NARCOOSSEE COVE I SPMP

SUMMARY

<p>Owner</p> <p>Al Yamama, LLC and AL Kharj, LLC</p> <p>Applicant</p> <p>Rick Ortiz, P.E. Poulos & Bennett, LLC</p> <p>Project Planner</p> <p>Michelle Beamon Robinson, AICP</p> <p>Updated: June 2, 2017</p>	<p>Property Location: Located south of Kirby Smith Road, west of Narcoossee Road and north of Tagore Place. (±32 acres, District 1).</p> <p>Applicant's Request:</p> <ol style="list-style-type: none"> 1. Request for a Specific Parcel Master Plan (SPMP) for the master infrastructure improvements and delineation of developable parcels within the property. The master infrastructure includes construction of a master stormwater pond, a master lift station, the north-south connector roadway, the two entrance roadway connections to Narcoossee Road and mass grading for the commercial outparcels, Lots 1 thru 3. <p>Staff's Recommendation:</p> <p>Approval of the request, subject to the conditions in this report.</p>

Proposed Development Plan

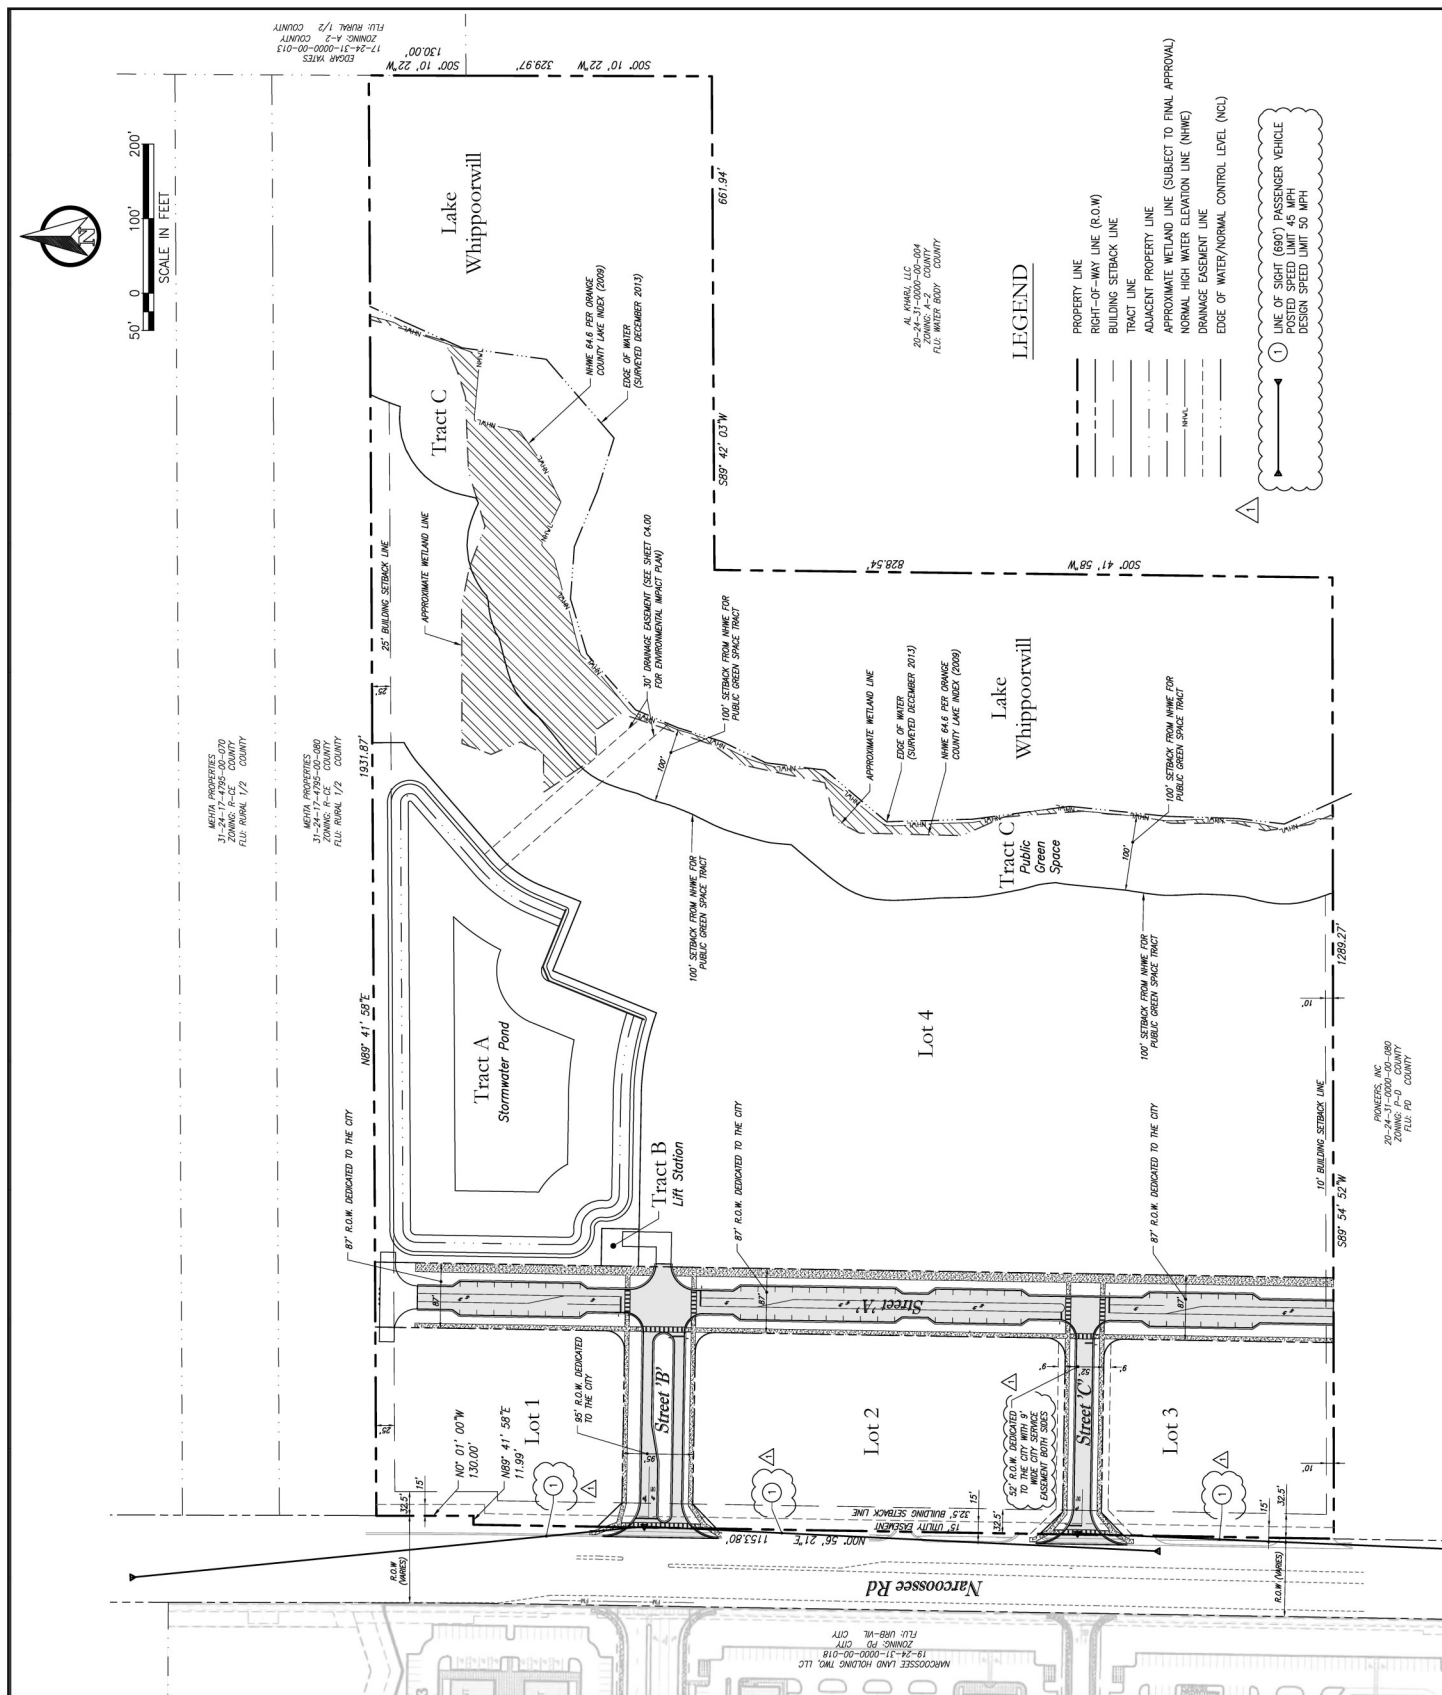
The lift station location is shown on the site plan on page 8 of this staff report. The lift station fencing/hedging appears to be directly adjacent to the multiuse trail. A buffer area of at least 2 feet shall be between the multiuse trail and the lift station hedging/fencing. The specific landscaping surrounding the lift station shall be evaluated at the time of permitting.

The required 25' buffer to the property to the north is shown on the site plan on page 8, as required by the PD.

The lift station location is shown on the site plan on page 8 of this staff report. The lift station fencing/hedging appears to be directly adjacent to the multiuse trail. A buffer area of at least 2 feet shall be between the multiuse trail and the lift station hedging/fencing. The specific landscaping surrounding the lift station shall be evaluated at the time of permitting.

Cross Sections

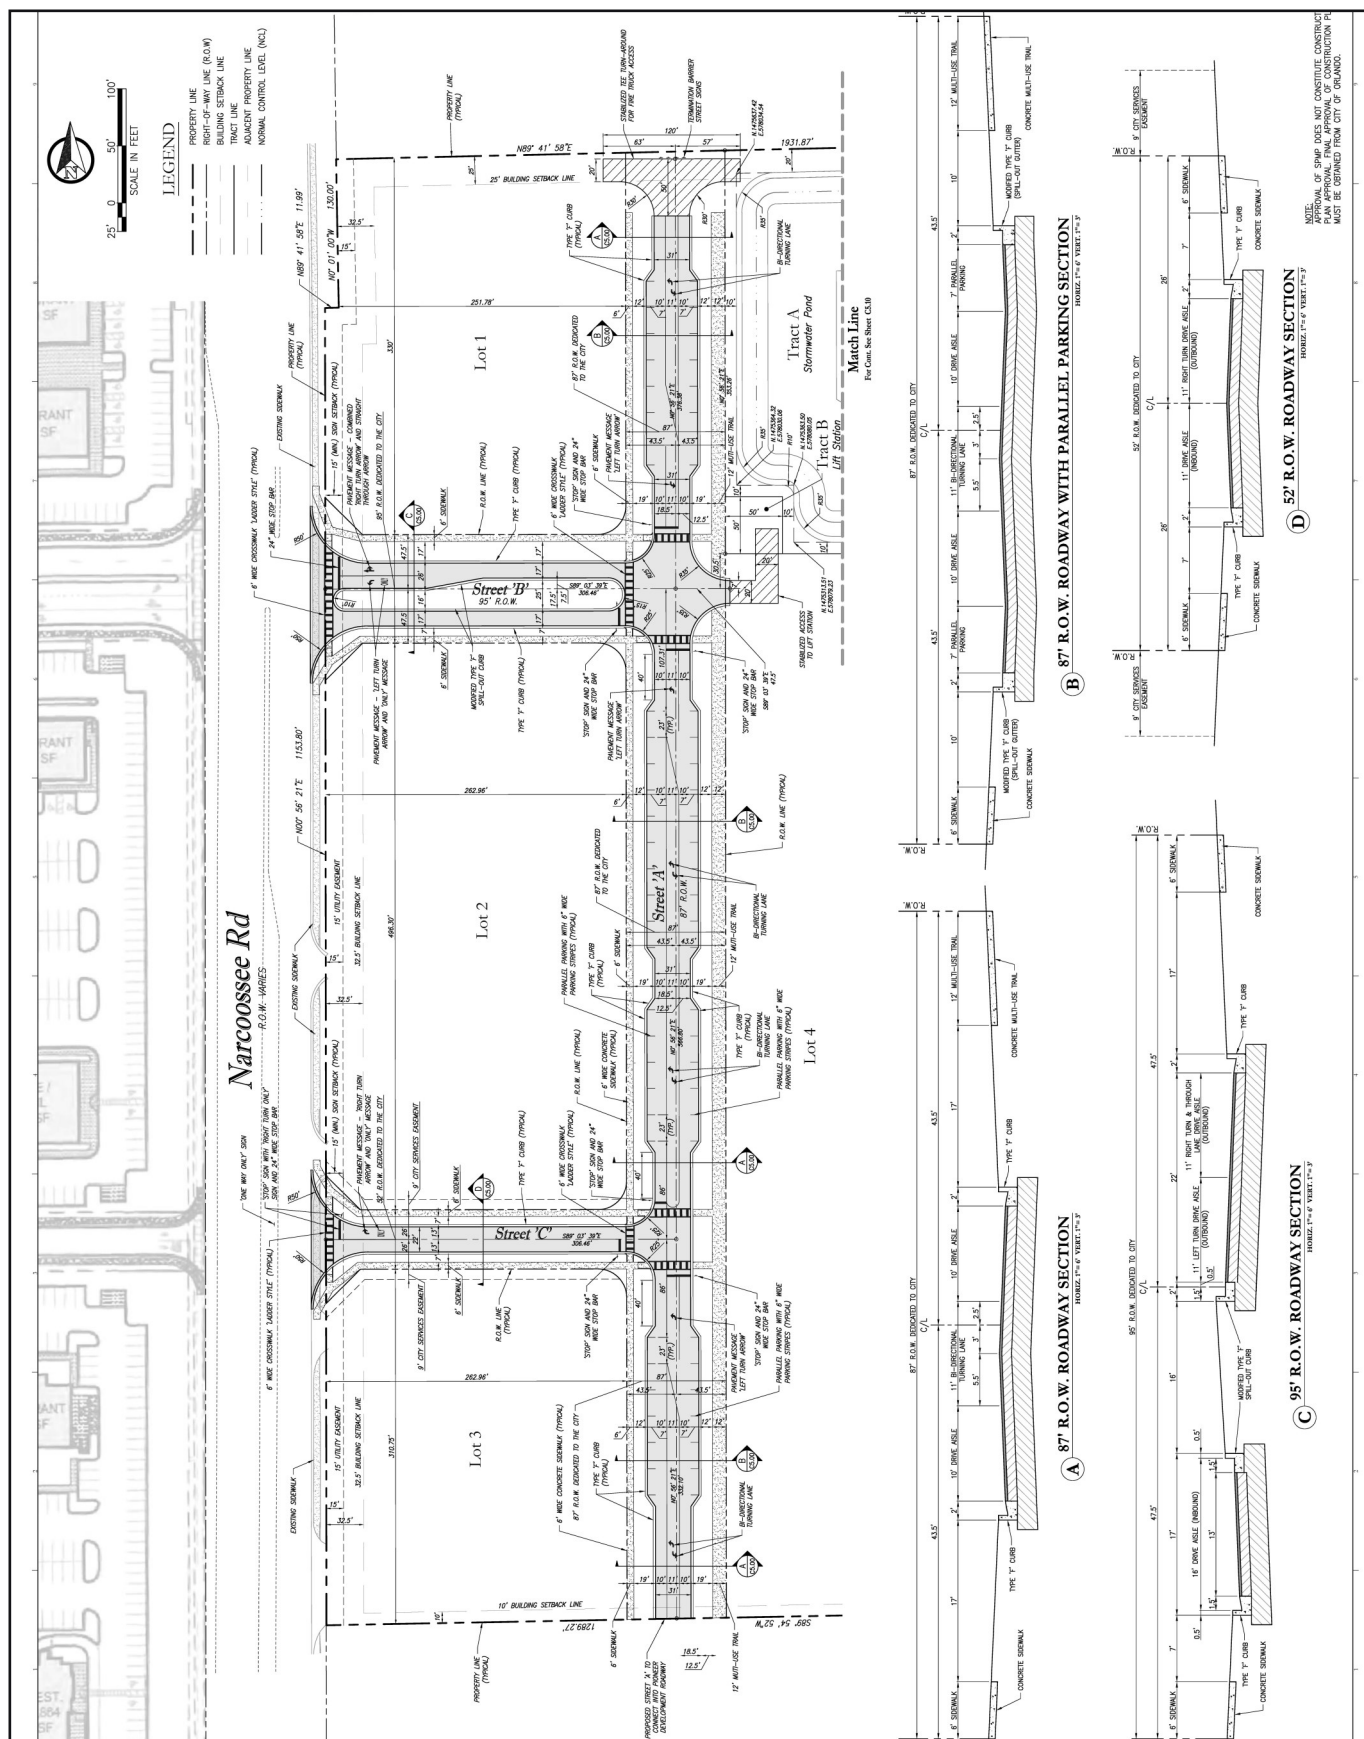
This submittal contains the roadway configuration and cross sections, see pages 9 and 10 of this staff report. The roadway configuration is consistent with the Development Plan that was approved as part of the PD. The site plan on page 11 displays the autoturn for the site, which is acceptable.

The cross sections located on pages 9 and 10 of this staff report are approved. These cross sections contain the street tree details as well as the required multiuse trail.

Paving, Grading & Drainage

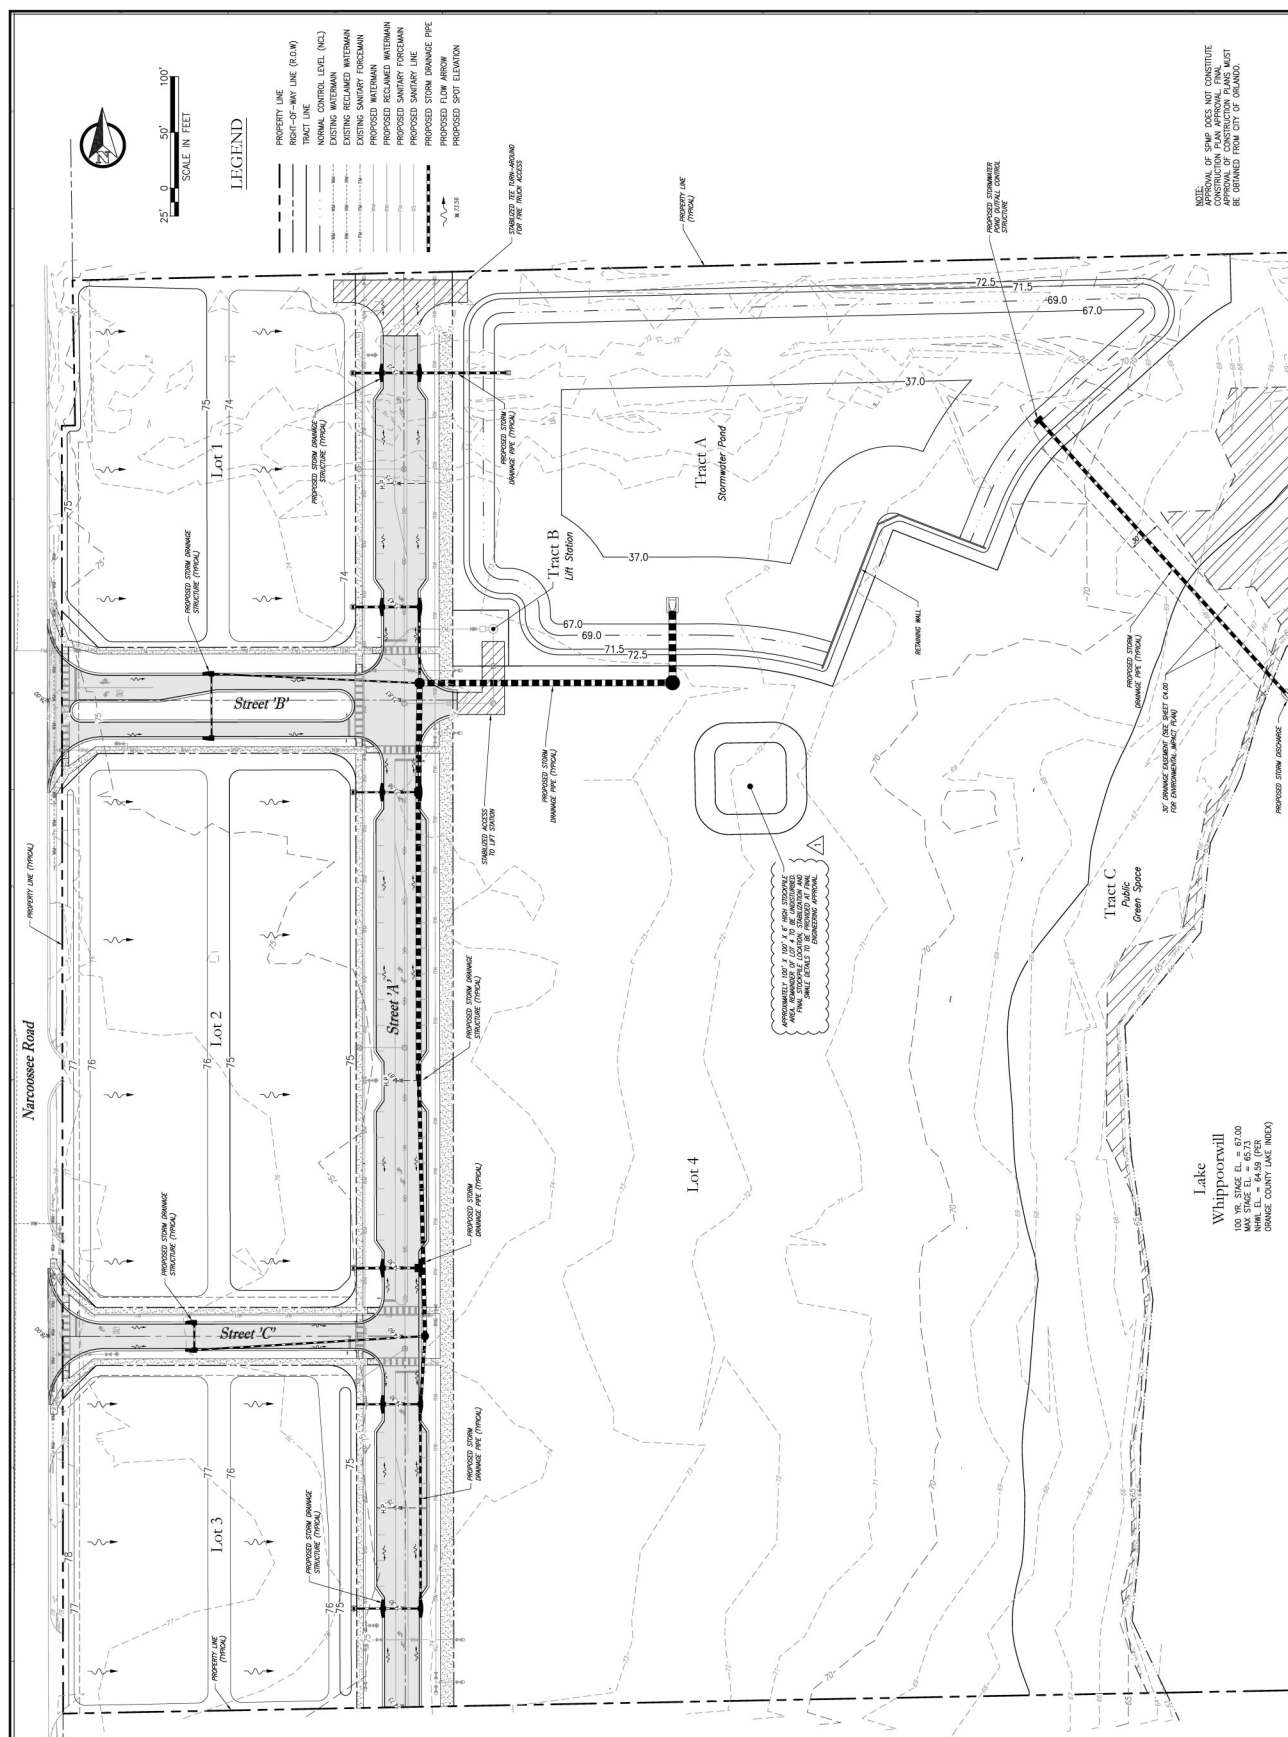
While Lot 4 is not permitted to be mass grading at this time, a 100' by 100' area on Lot 4 is approved to be used for soil placement/stock pile. The location of the soil placement is identified on the paving, grading and drainage plan on page 12 of this staff report. This is for the soil that is removed to create the stormwater pond and is a temporary pile that shall be removed with the development of Lot 4.

While Lot 4 is not permitted to be mass grading at this time, a 100' by 100' area on Lot 4 is approved to be used for soil placement/stock pile. The location of the soil placement is identified on the paving, grading and drainage plan on page 12 of this staff report. This is for the soil that is removed to create the stormwater pond and is a temporary pile that shall be removed with the development of Lot 4.
